SUBJECT: Cairo Regional Airport
Cairo, Illinois
Alexander County
Illinois Project Number: CIR-4364
SBG Project Number: 3-17-SBGP-95/99/105/111
Contract No. CI005
Item No. 6A, June 16, 2017 Letting
Addendum A

NOTICE TO PROSPECTIVE BIDDERS

Reason for Addendum:

Addition of AR162624 gate to project quantities
Modify notes on page 8 -9 to show 8' fence

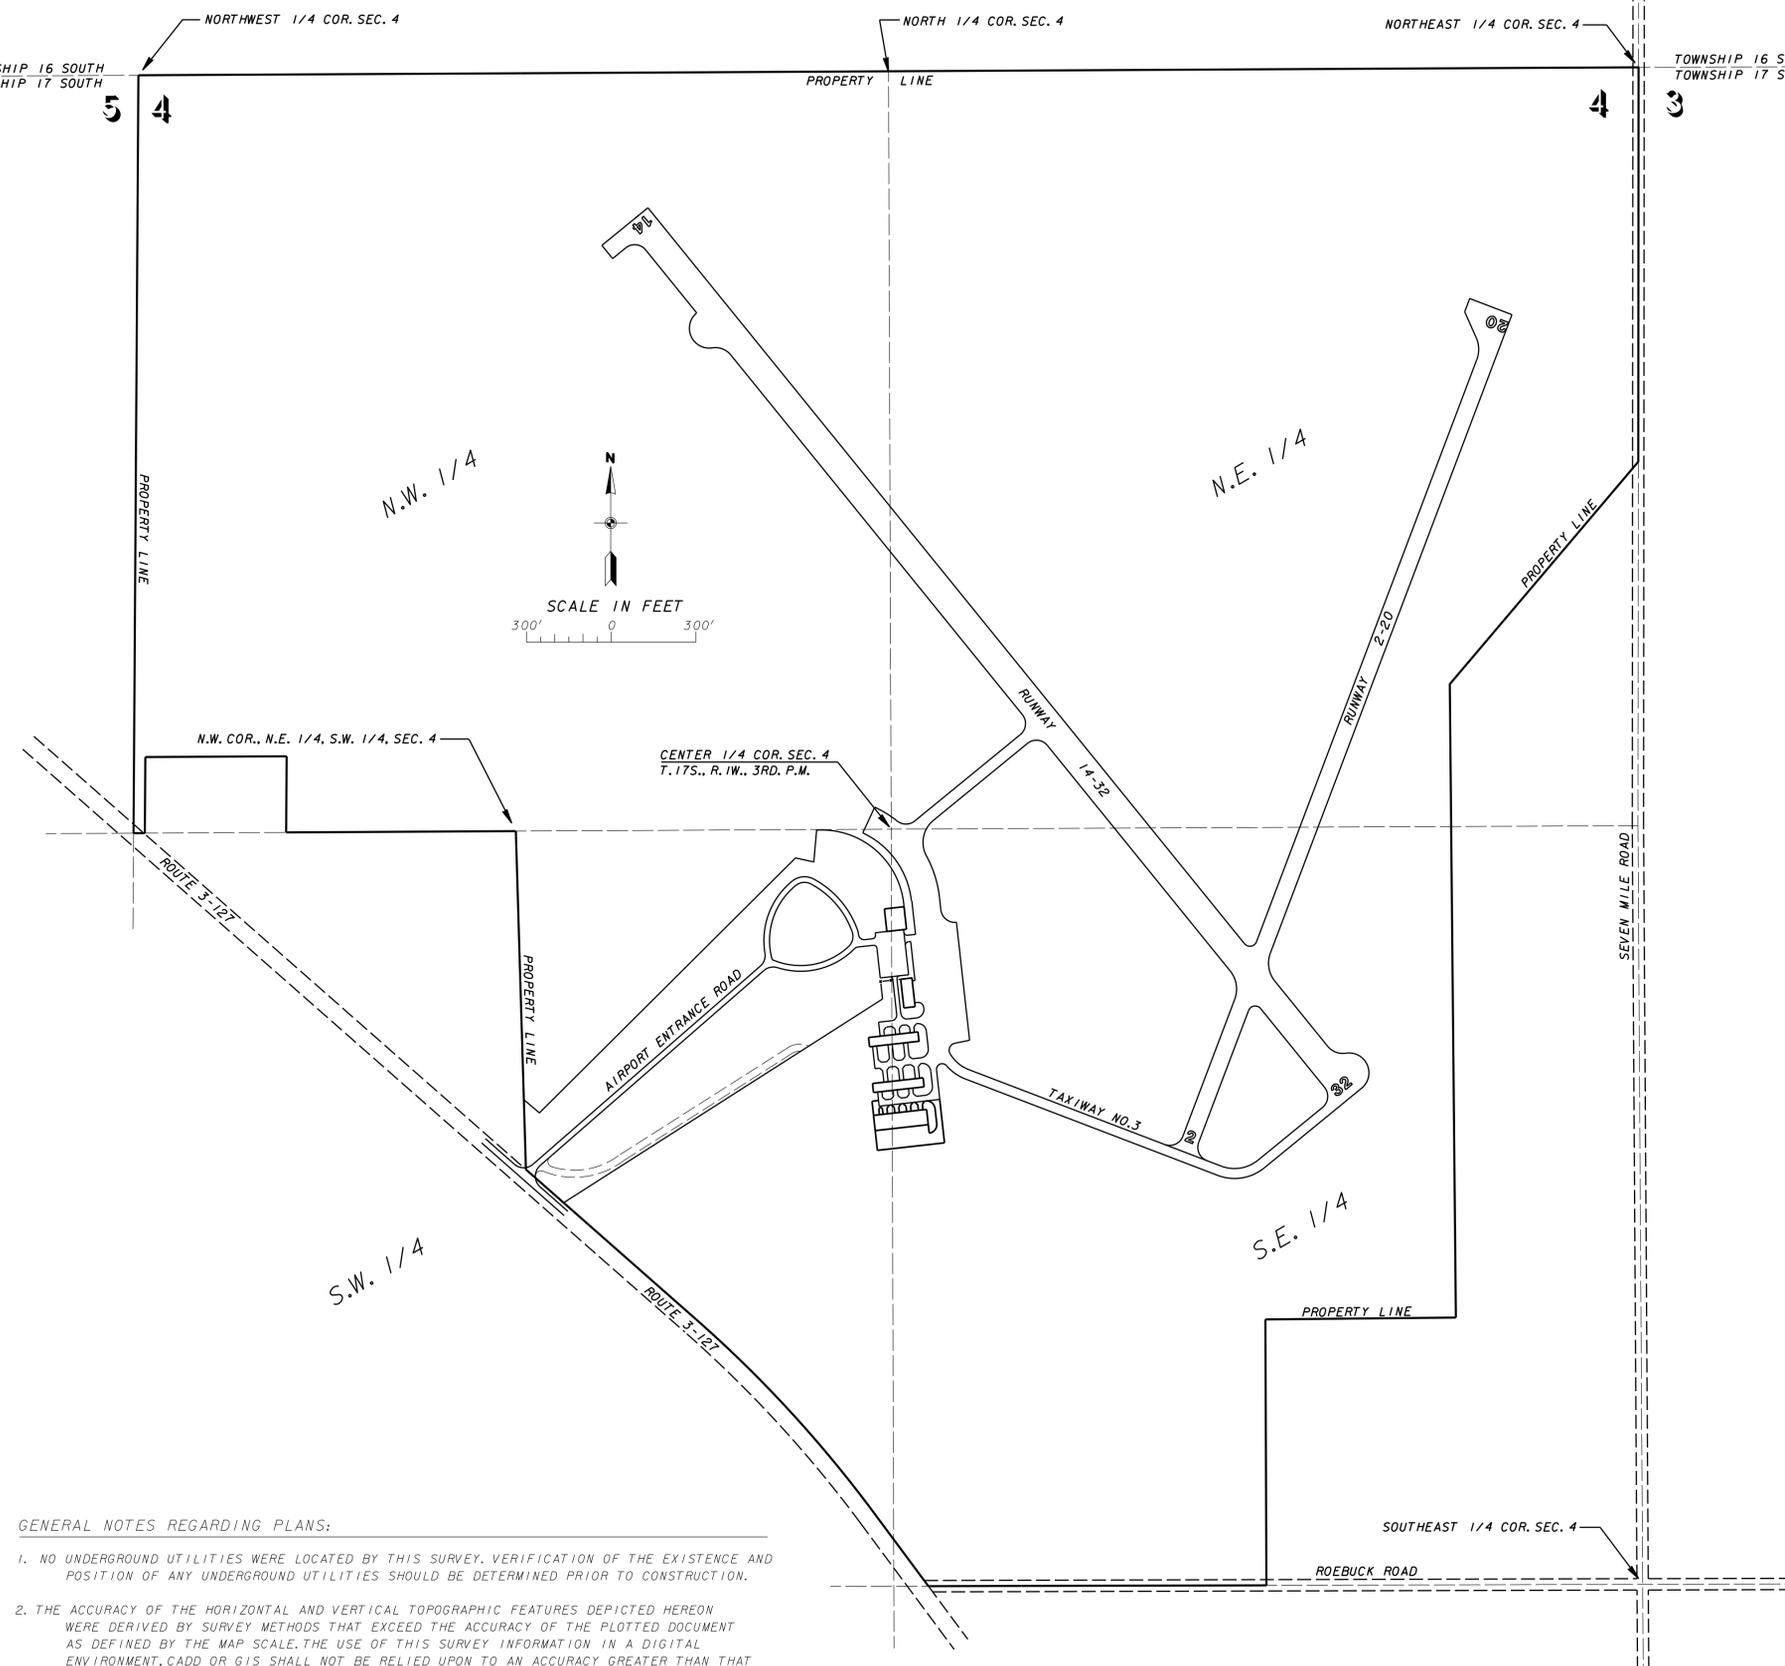
Plan Sheet 2 – Revise Summary of Quantities. Schedule of prices have been updated as well.

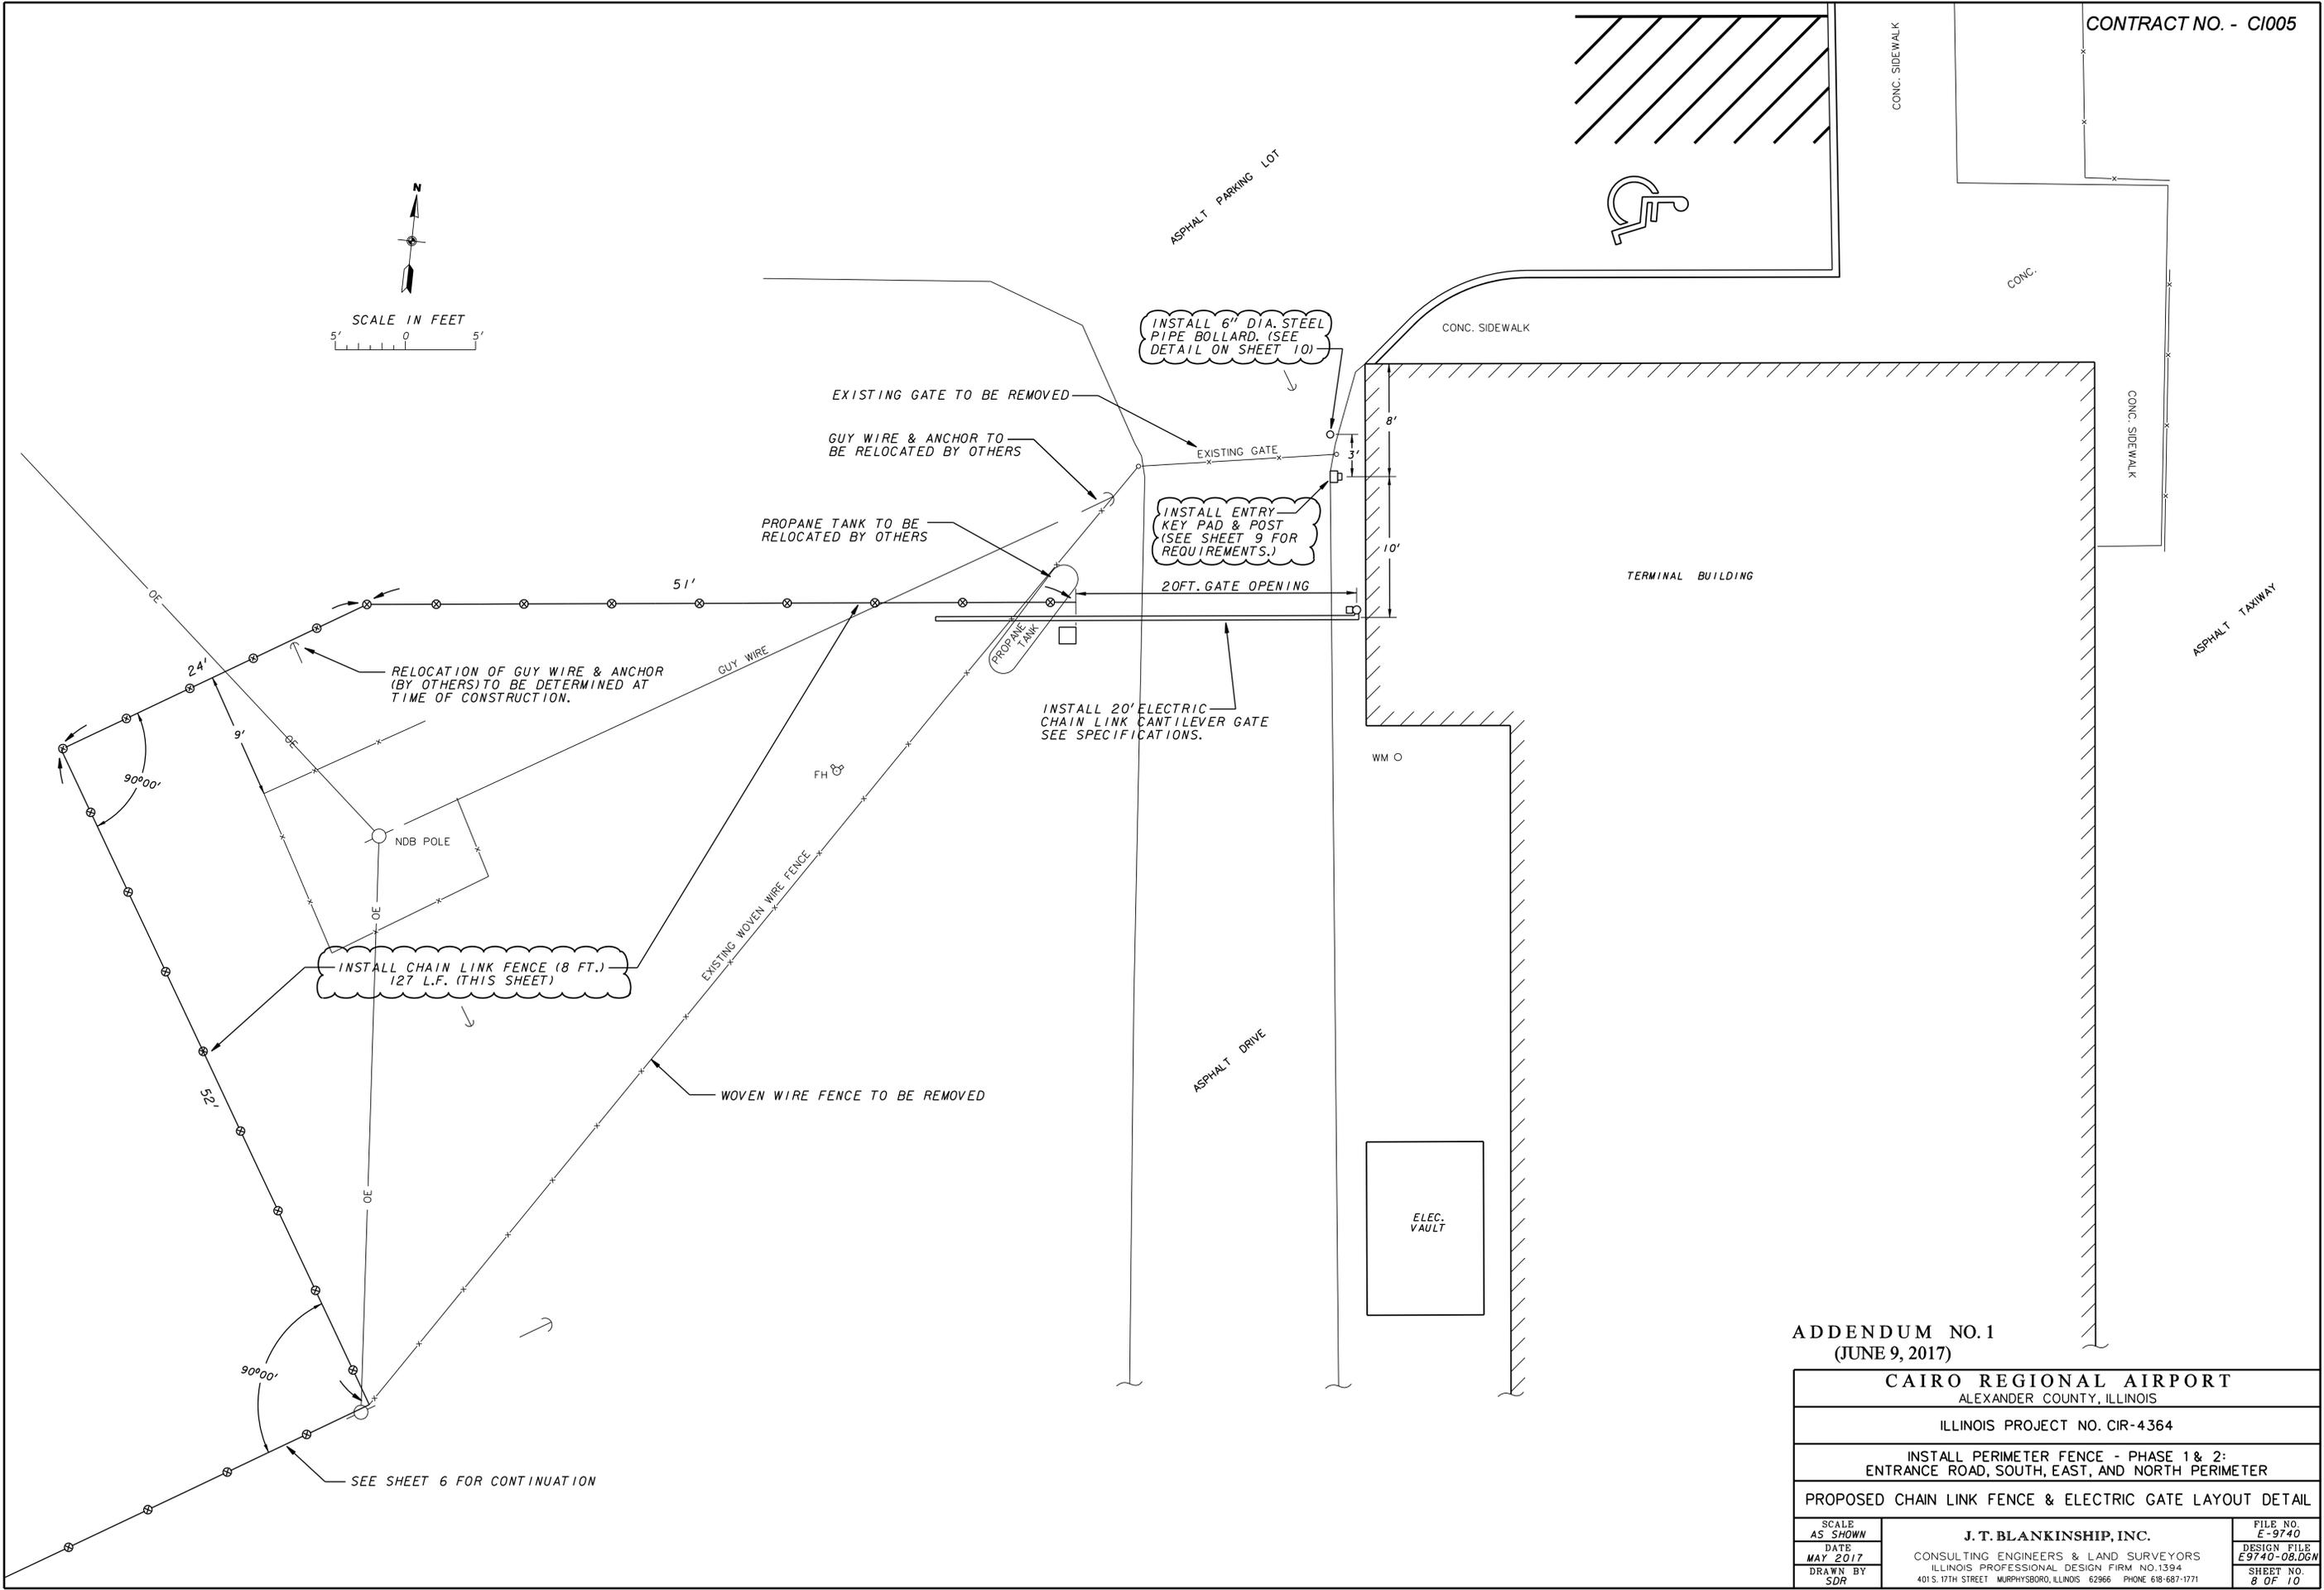
Plan Sheet 8 – Revise page references and change all references of 4' fence to 8' fence.

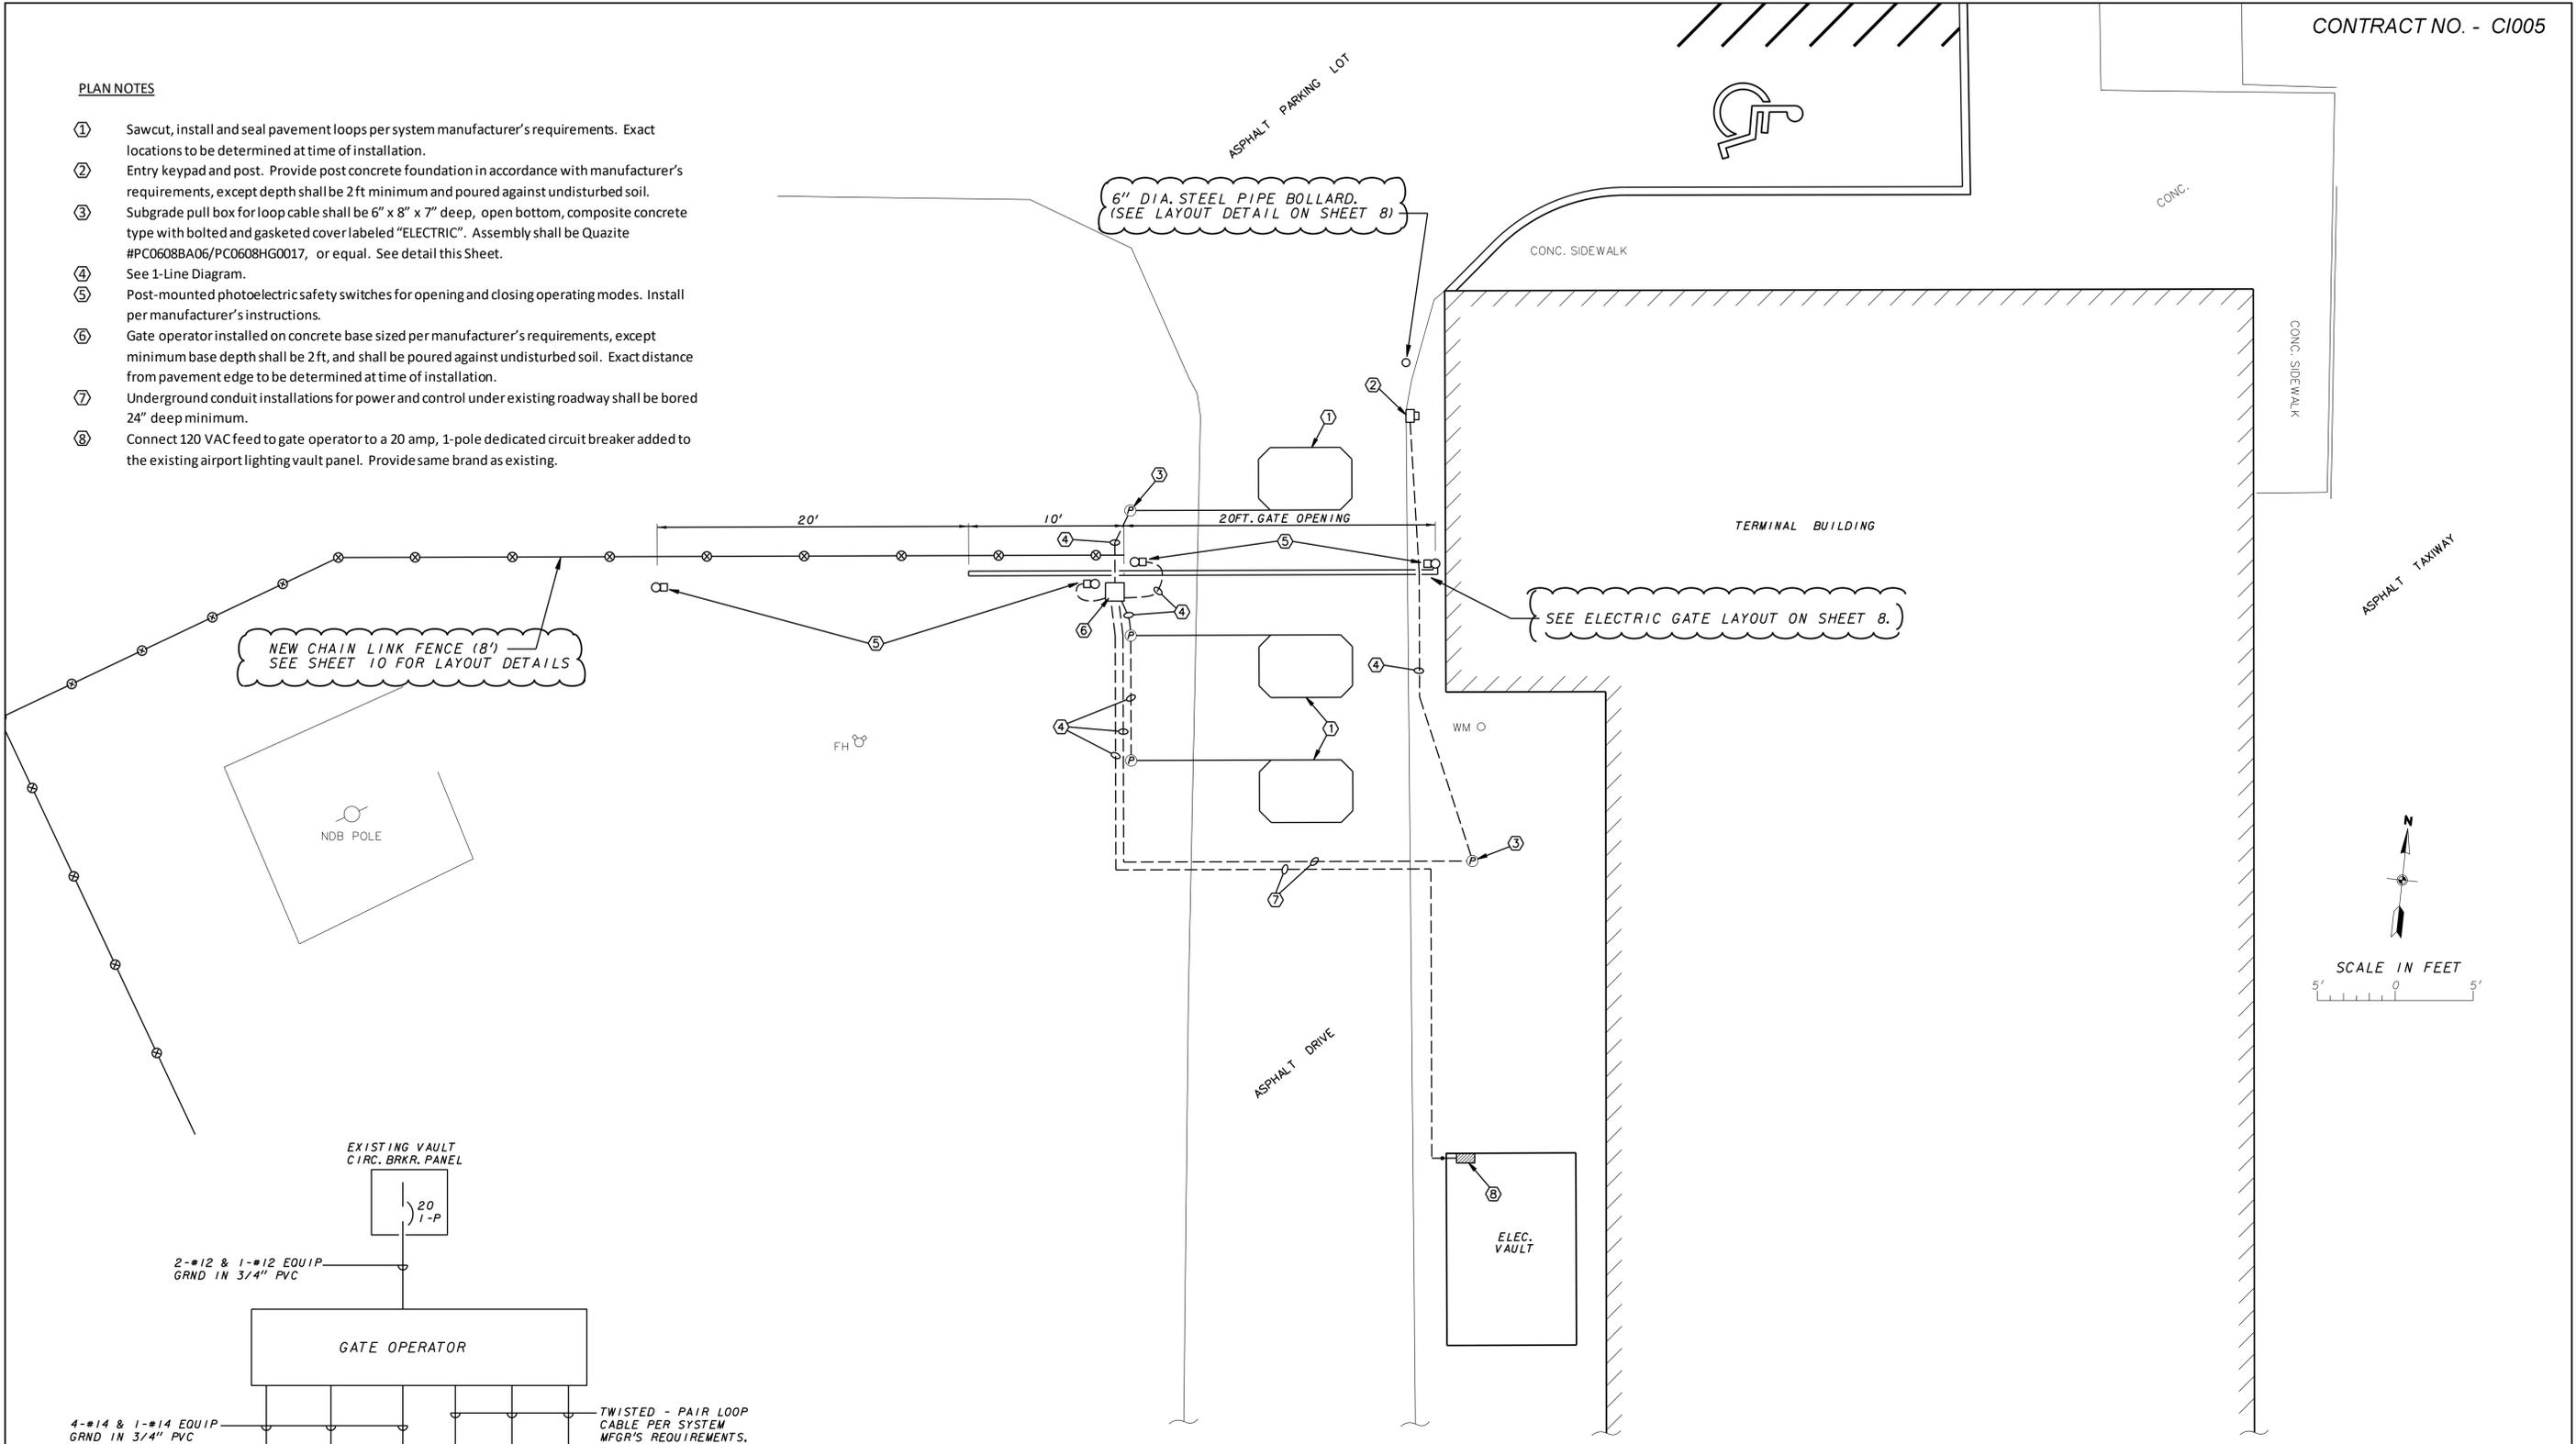
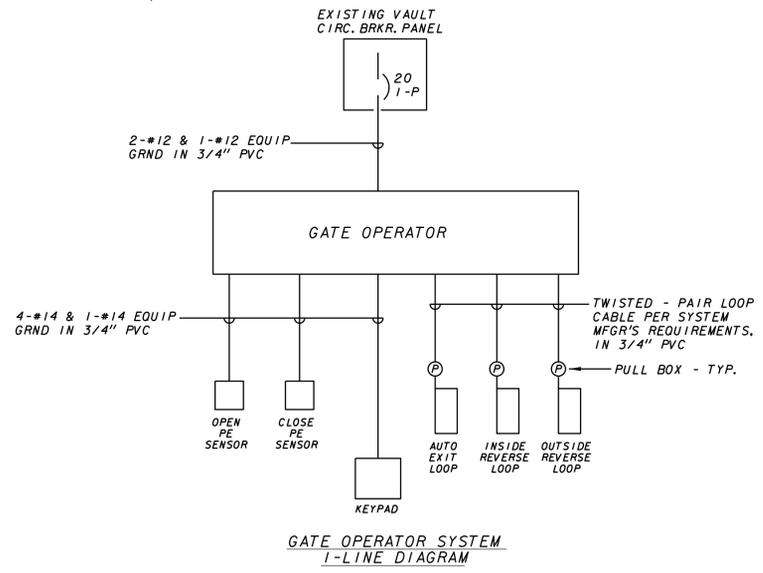
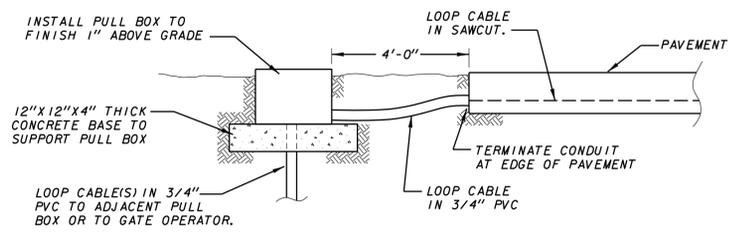
Plan Sheet 9 – Revise page references and change all references of 4' fence to 8' fence.
